MIL-C-60623(MU)
AMENDMENT 2
28 September 1967
SUPERSEDING
AMENDMENT 1
4 May 1967

CASE, CARRYING: 10527433

This amendment forms a part of Military Specification MIL-C-60623(MU), dated 30 November 1966.

FIGURE 3 - SHELL, BODY

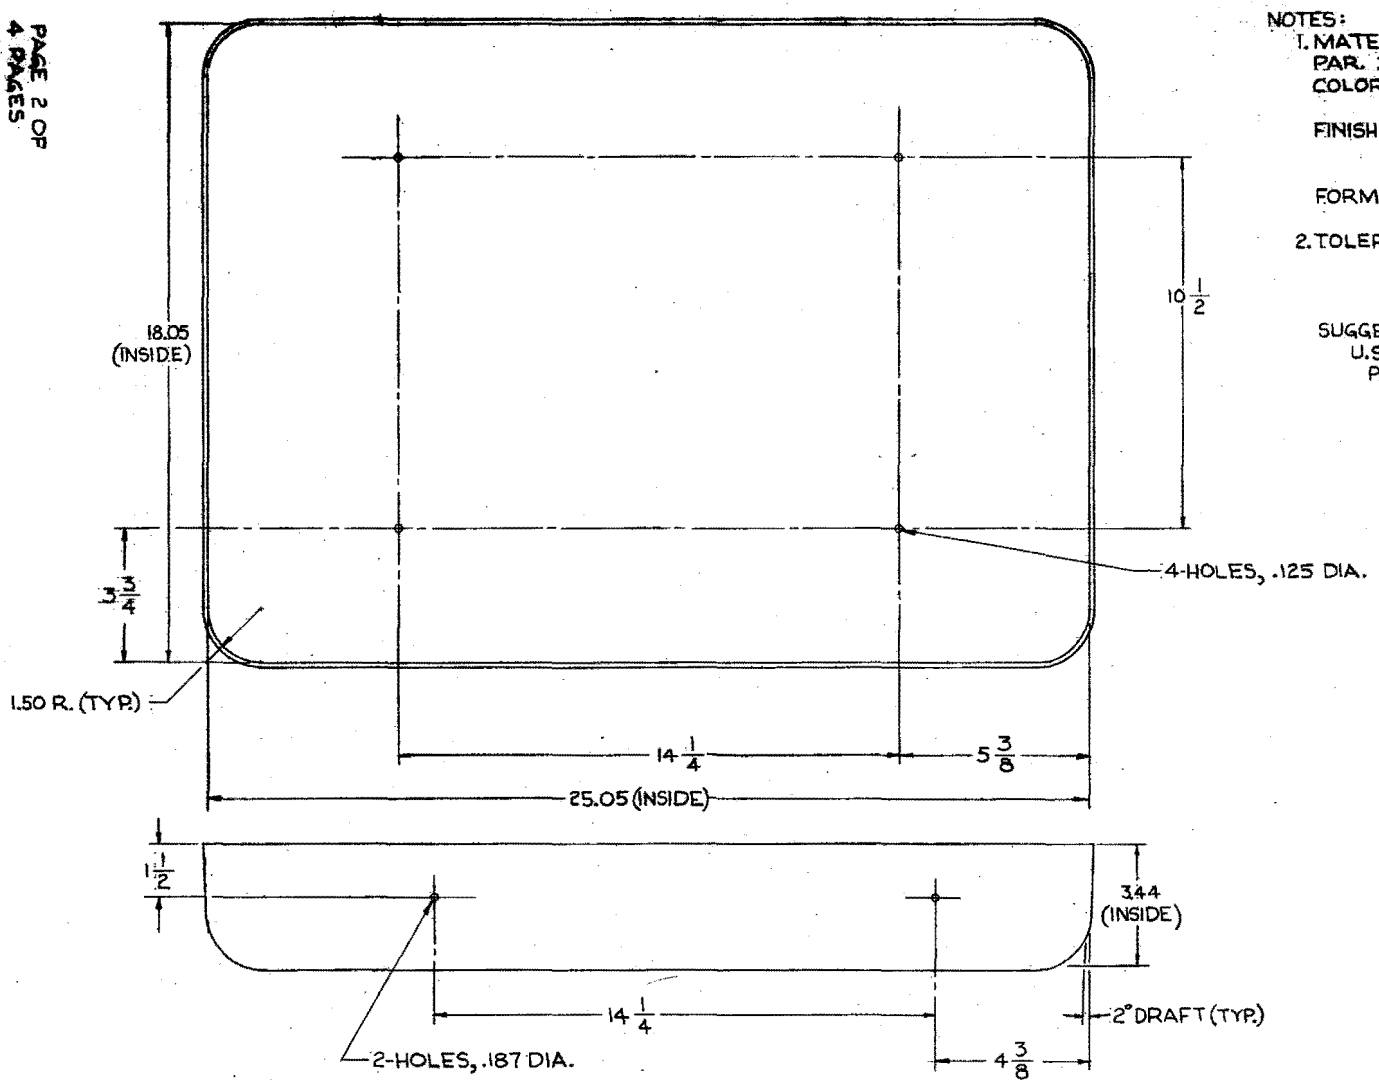
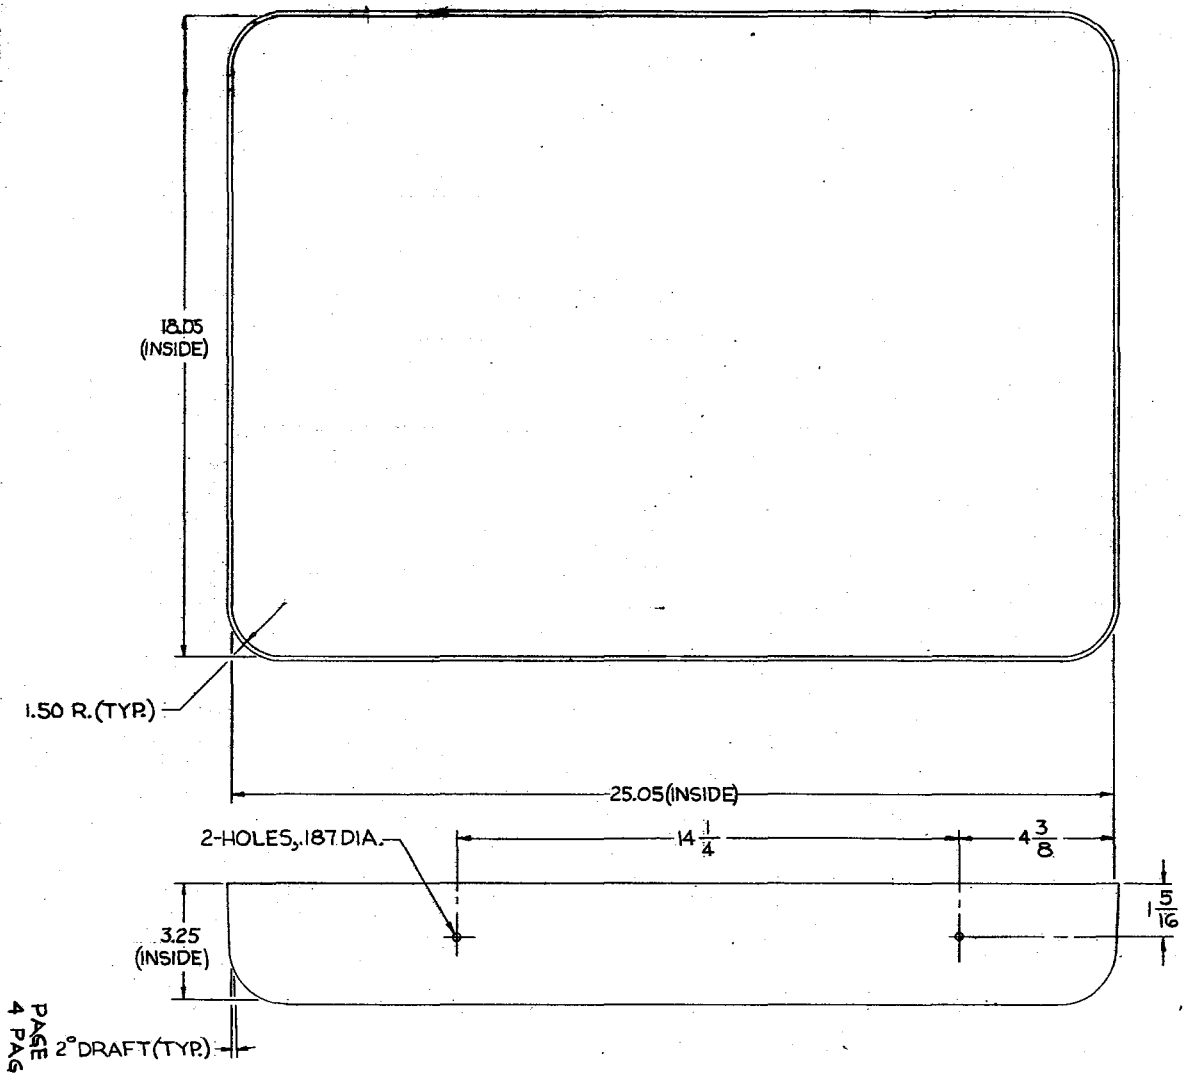
Delete: "Figures 3, 4 and 8" and substitute attached "Figures 3, 4 and 8."
